memorandum

Santana Minerals Ltd DATE 17 March 2026

RE Bendigo-Ophir Gold Project Air Quality Assessment Addendum: Visual Dust Monitoring and Instrumental Arsenic Dust Monitoring.

Figure 1: BOGP site boundary

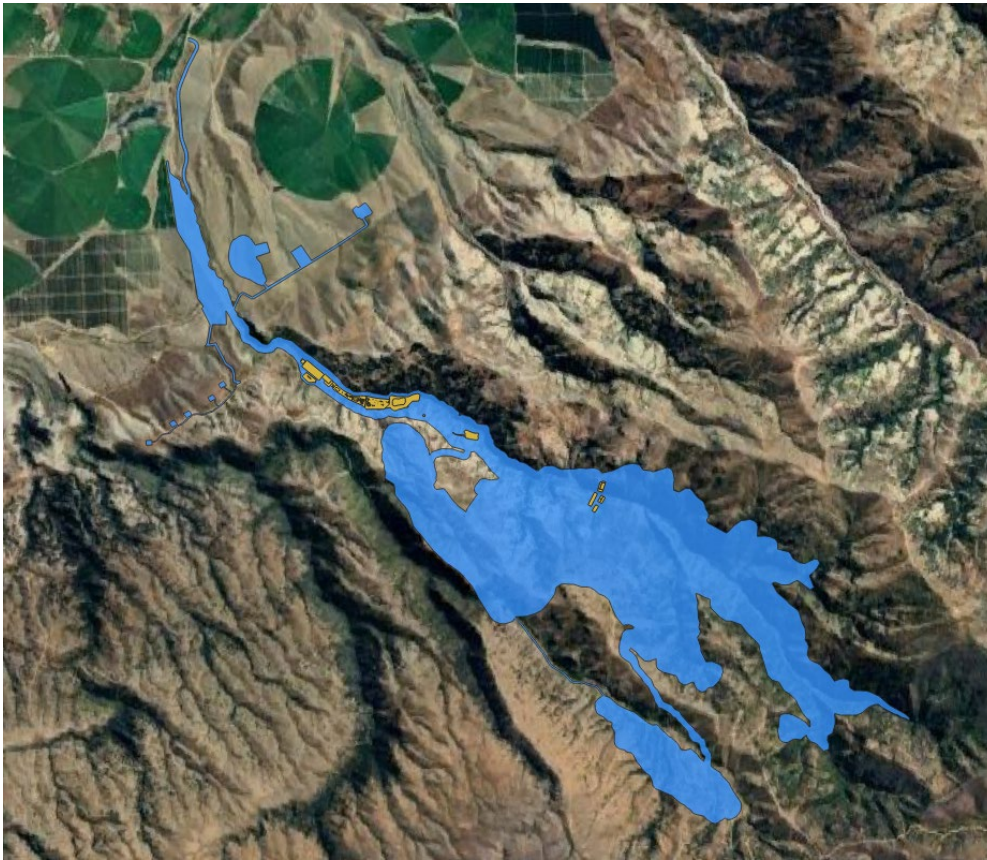
SLR considers the previous response incomplete and states: *"Please provide a more detailed explanation of how the "visible dust crossing the boundary" trigger will operate in practice, given that workers in the valley cannot actually see the boundaries"*.

The BOGP site boundary is shown in Figure 1.

There are no fences or boundary markers for the majority of the site boundary which would enable BOGP staff to assess whether dust plumes are travelling over the boundary. Therefore, they will be required to understand and identify the site boundaries using landmarks.
